**HOWELL TOWNSHIP PLANNING COMMISSION**

**SPECIAL MEETING**

**Site Plan Review  
For  
Howell Township, Michigan**

RE: Old Glory Car Wash  
4120 Grand River Avenue, Howell Township  
Preliminary Site Plan Review

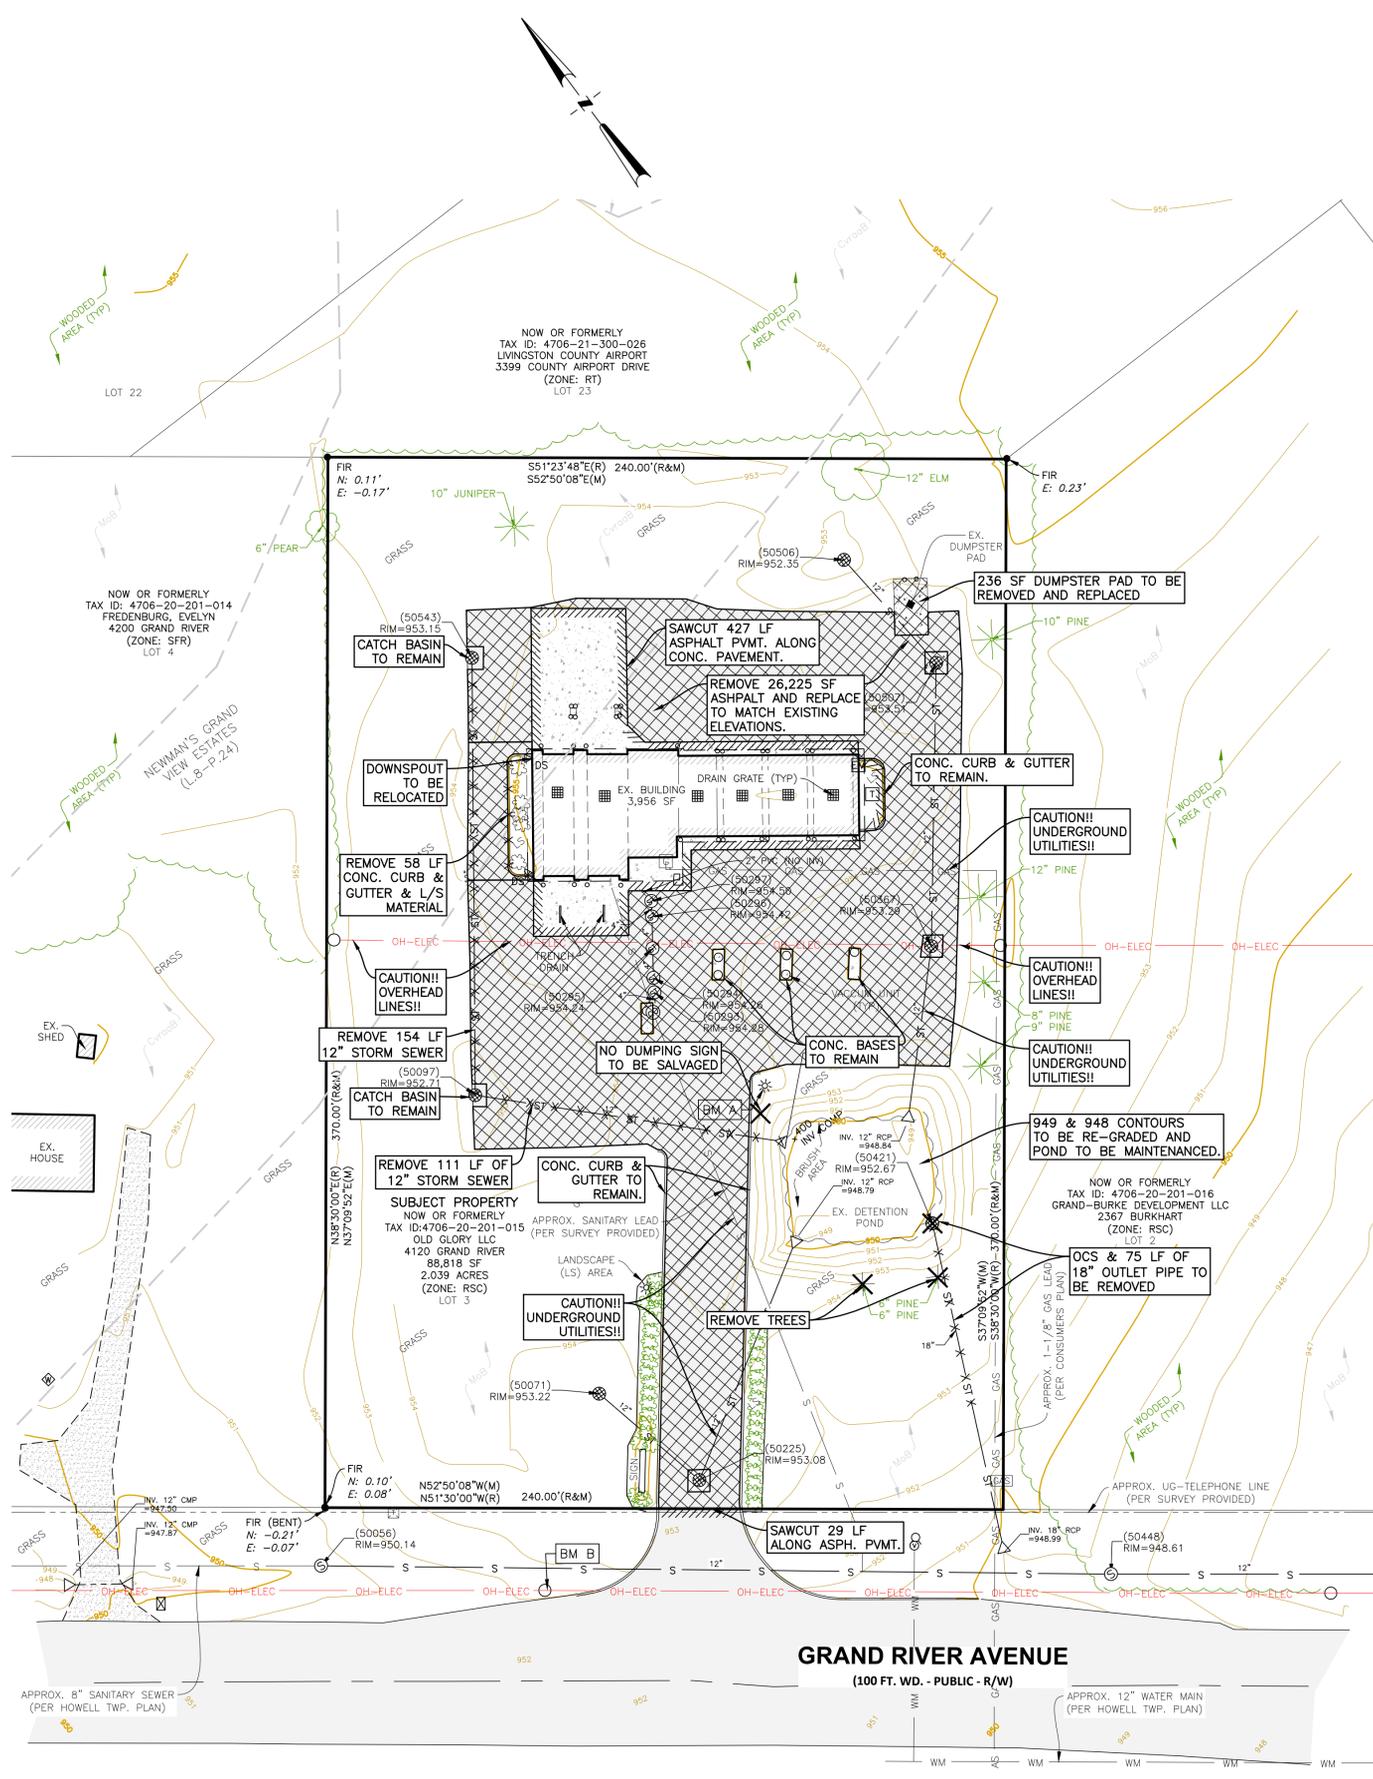
**Items to be Addressed:** 1) The height of the proposed building should be clarified on Sheet C.1.0. 2) The applicant will need to revise plans or apply for a variance to approve the proposed structure setbacks of the detention pond.

The correct setbacks are listed and shown on the plans; however, the proposed detention ponds and security chain-linked fence are within the 35-foot front setback. The pond must be relocated outside of the influence of the 35-foot front setback, or a variance must be granted by the zoning board.

The site has one, two-way, drive that is assumed to be 29' wide to match the existing, this dimension should be included on the paving plan. The demolition plan shows the existing pavement being sawcut at the R.O.W. and leaving the existing approach. We defer further comment on the approach to Livingston County Road Commission.

1. A variance has been applied for to have the detention basin in the front setback. The ZBA meeting is April 16<sup>th</sup>, 2024.
2. The height of the building has been added to Sheet C-1.0.
3. The number of employees is listed on Sheet C-1.0 for parking calculations.
4. Parking spaces have been added to Sheet C-1.0.
5. The landscape plan is in the process of being revised.
6. The landscape plan is in the process of being revised.
7. A lighting plan is in progress. Once completed it will be included in the plan set.
8. The trash enclosure has been included and a detail added to the plans.

**PROPOSED PARKING**

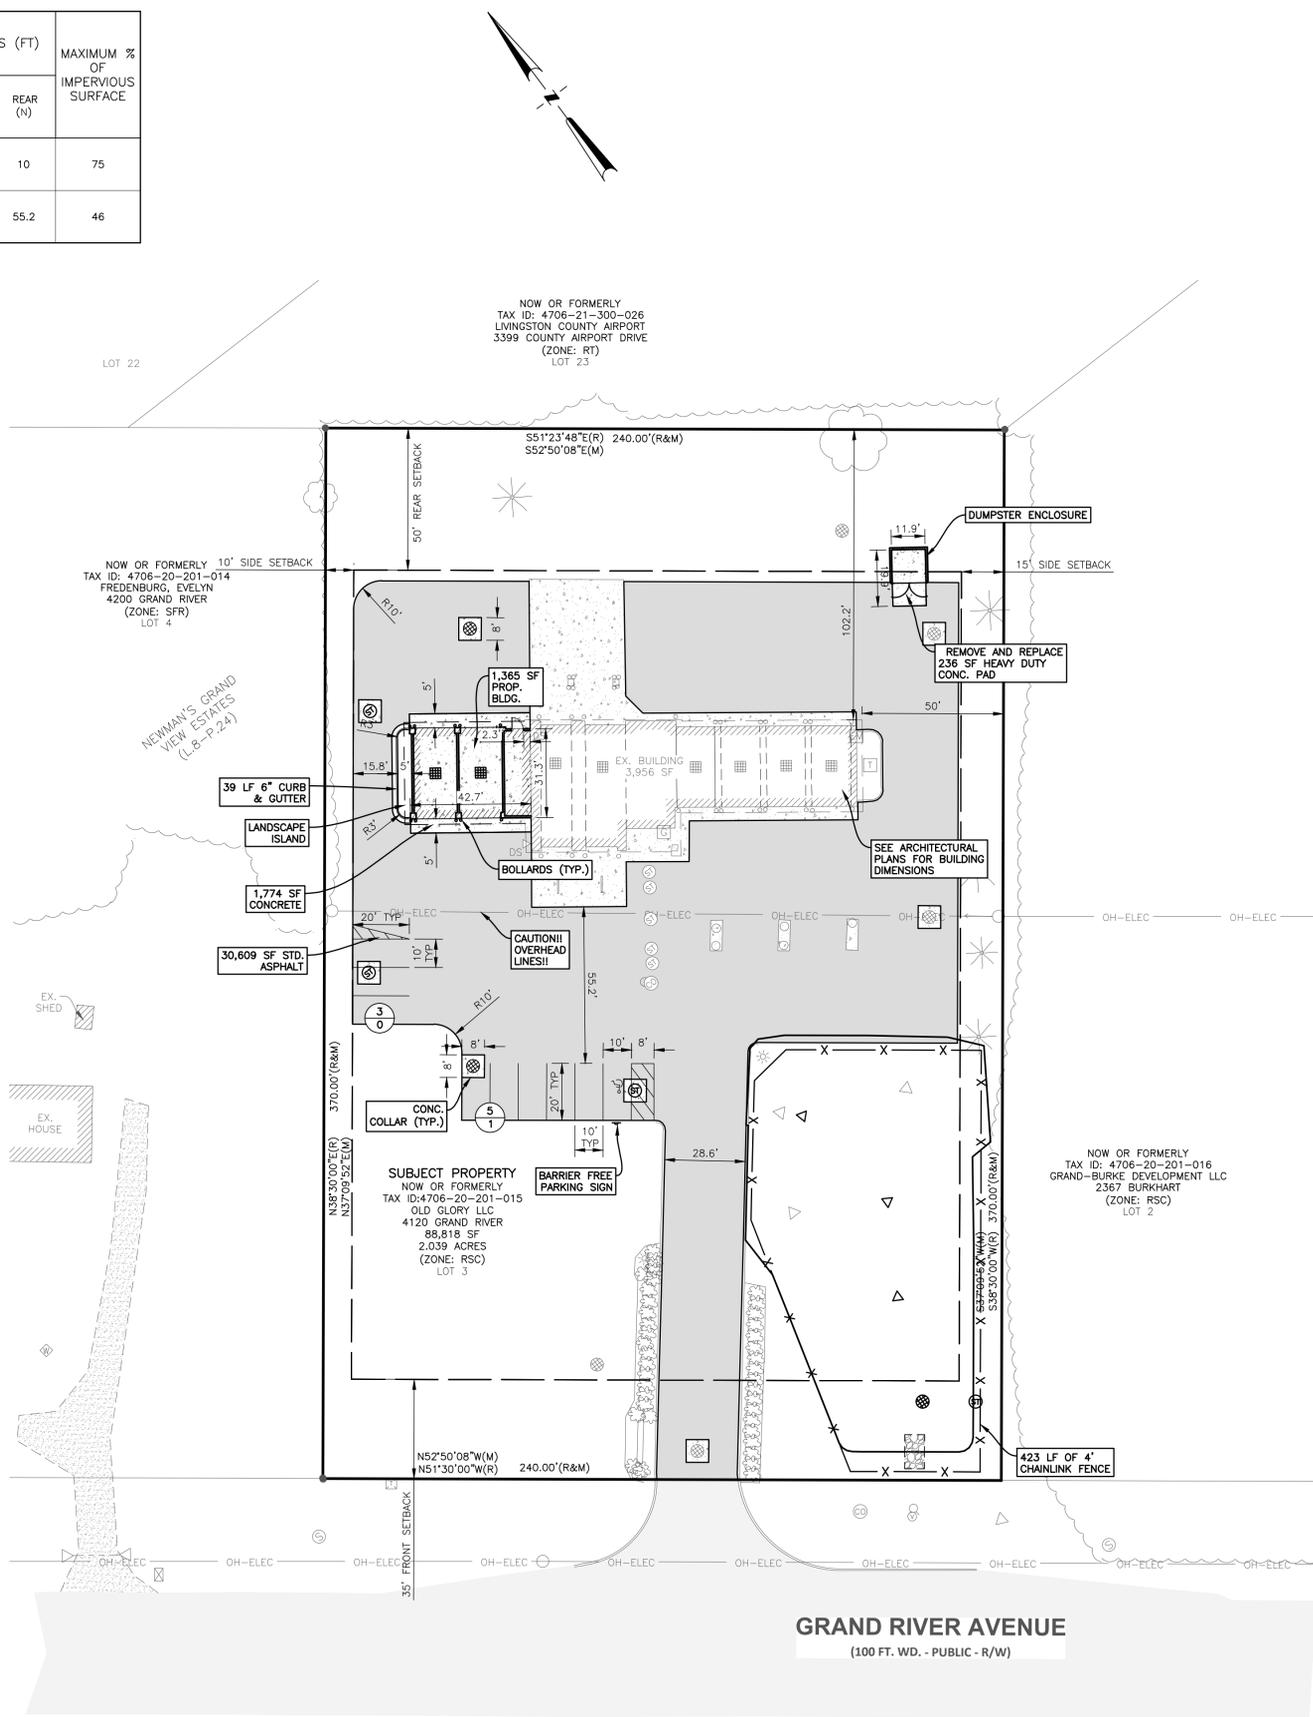
The applicant notes that the current site does not include any striped parking and does not include any in the site plan. Per section 18.02.G.5, which sets requirements for Gasoline filling and service stations, one (1) space for ea. service bay, plus one (1) space for ea. employee working during maximum employment (Sec. 18.02.G.5 – Gasoline Filling and Service Stations).

There is no number of employees indicated on the plans.

Because the bays are self-service or drive through, there is no need to provide parking for them, however, the applicant must provide the number of employees at maximum employment and show adequate parking to meet the requirements of Section 18 accounting for maximum employee parking and service bays.

1. The applicant shall request a variance to approve the proposed structure setbacks of the detention pond or revise plans to meet the Ordinance requirements.
2. The height of the proposed building should be listed on Sheet C.1.0.
3. List the number of employees at maximum employment.

4. Demonstrate adequate parking for the site as defined in Section 18.02.G.5 for Gasoline Filling and Service Stations.
5. The number of existing shrubs surrounding the detention pond should be clarified.
6. The two (2) pine trees currently counted toward the stormwater detention pond should be clarified if they are to remain or be removed.
7. The applicant shall provide light fixture details and a photometric plan that demonstrates compliance with Section 14.22.
8. The trash enclosure screening should be included in the plans with the height and material listed.
